Office Action Summary	Application No. 10/077,496	Applicant(s) TSUGITA ET AL.	
	Examiner Vy Q. Bui	Art Unit 3731

DETAILED ACTION

Notice that the distal end portion/sleeve 18 of filter 12 is capable of being slid along guidewire 42 over stop/hook/stop-receiving member 44 from a first position proximal to the stop to a second position distal to the stop 44 as indicated in the following reproduced drawing 3C:

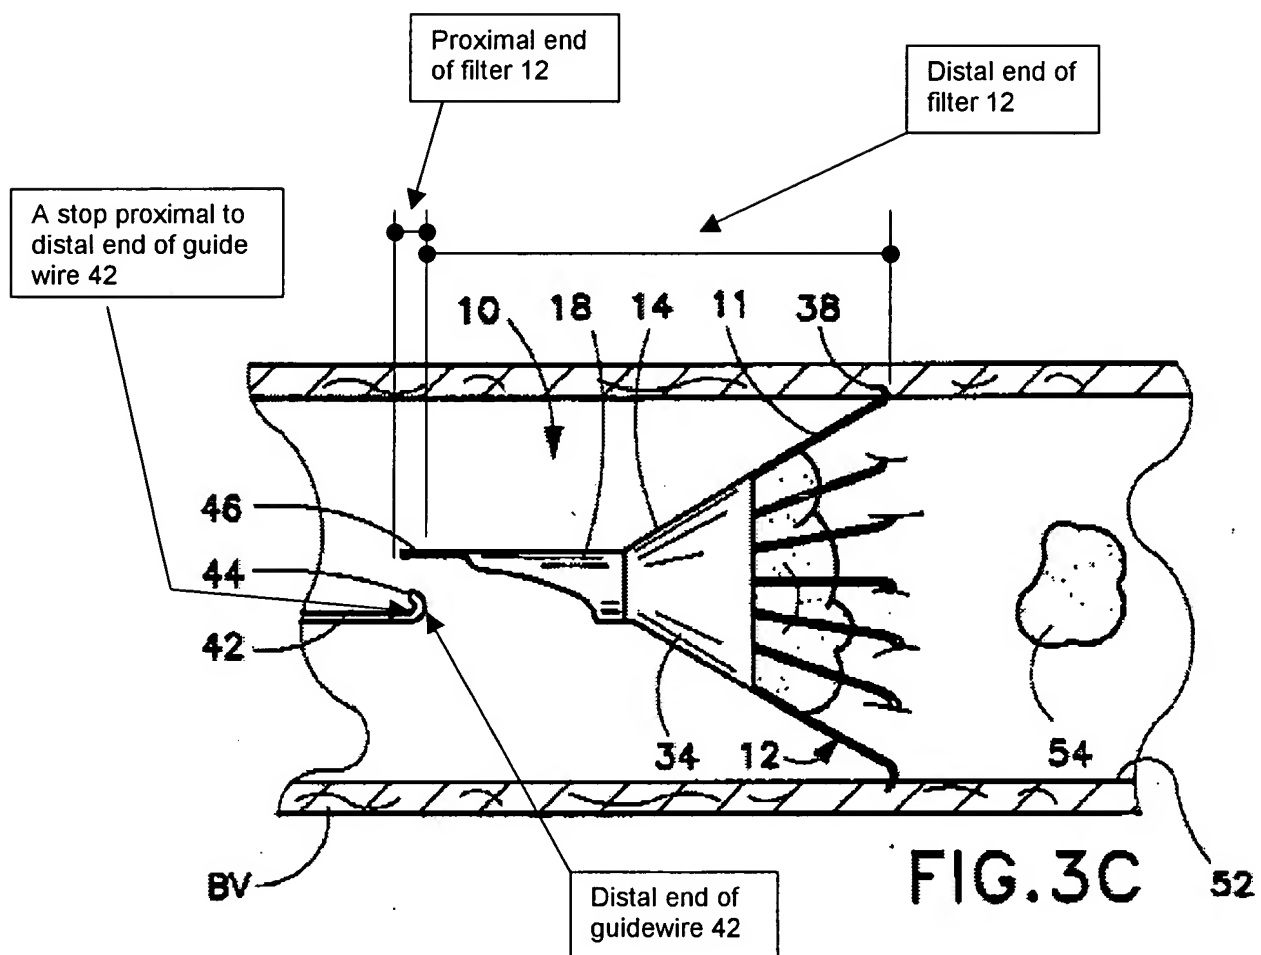
As shown in Figures 3a-3c, for example, it is reasonable for one of ordinary skill in the art to recognize Gelbfish' filter 12 having different elements such as prongs/tines 11, access port/sleeve 18 and finger 46. As such, one can recognize distal end of filter 12 is also distal end of finger 46. Further, wire 42 having hook/stop 44 at the distal end can be reasonable considered as a guidewire because finger 46/filter 12 can be guided or slidably disposed along

at least a portion of guidewire 42 and retained by hook/stop 44 as recited by the claims. Further more, at least when the proximal and distal ends of the filter 12/46 are specified as shown in Fig. 3C reproduced above, it is clearly that Gelbfish device is capable of performing in a manner as recited in the claims. Notice that there is no specific limitation in the claim to clearly define the boundary between the distal end and the proximal end of the filter 12/46.
